From: Lucy Owen <lucy.owen@pla.co.uk>
Sent: 11 August 2021 17:22
To: Planning Admin
Subject: 20210757 - Custom House, Gravesend (DC857)

Thank you for your letter dated 20 July 2021 regarding the re-development of the site and conversion of the existing building to provide 27 residential units with associated landscaping, parking and vehicular access. I have now had the opportunity to review the submitted documentation and would advise that the PLA **objects** to the proposed development.

Layout of the Proposed Development

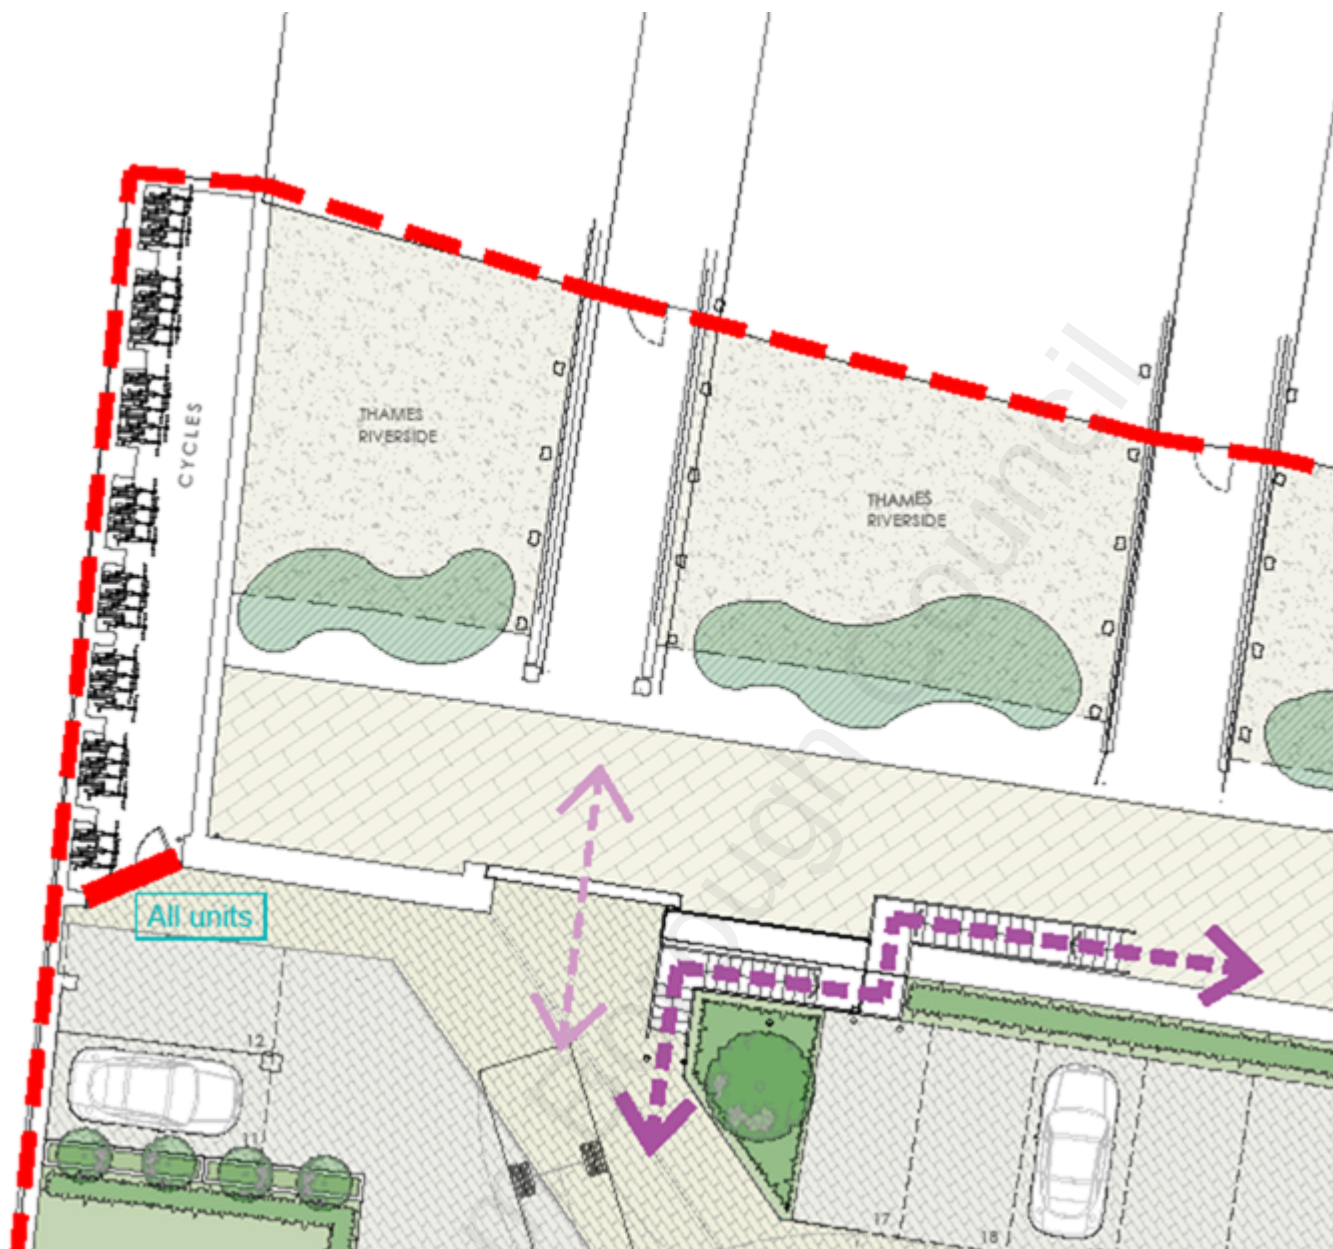
Design should be used to minimise the potential for conflicts of use and disturbance rather than relying on mitigation measures alone. The PLA is concerned about the proximity of the proposed residential development to the boundary of the PLA's Gravesend Complex. As the image below (taken from the application documents) shows, an existing building the 'Boat House' is to be repurposed for residential use and windows are to be introduced along the boundary, directly overlooking the PLA's car park. A new building is proposed with windows overlooking the PLA's site and this building appears to be immediately on the boundary (and potentially utilising the boundary wall) with the PLA's car park. Notwithstanding the logistical issues that may arise from constructing a building so close to the PLA's land and whether it would be possible, without entering onto/over the PLA's property, it raises significant issues about whether the development has been designed to minimise the potential for disturbance and complaints. The addition of bedroom windows at first floor level which would open onto/over the car park combined with the PLA's activities including 24/7 vehicle movements, means that there would be a high probability of complaints from residents. The PLA's Health and Safety requirements mean that all vehicles are reversed parked in the car park and residents would therefore be subjected to emissions from vehicles as well as noise from vehicles reversing (which would include audible warnings on vans etc about vehicles reversing). The designated smoking area is along the boundary as is the designated muster point.

The PLA would re-iterate its comment above that specific reports should assess the potential juxtaposition issues and the design of the development should be given specific consideration, with as a minimum, the new building being set back from the boundary at a similar distance to the existing building and the internal layout of the buildings being re-configured to remove windows from the elevation and habitable rooms from the boundary.
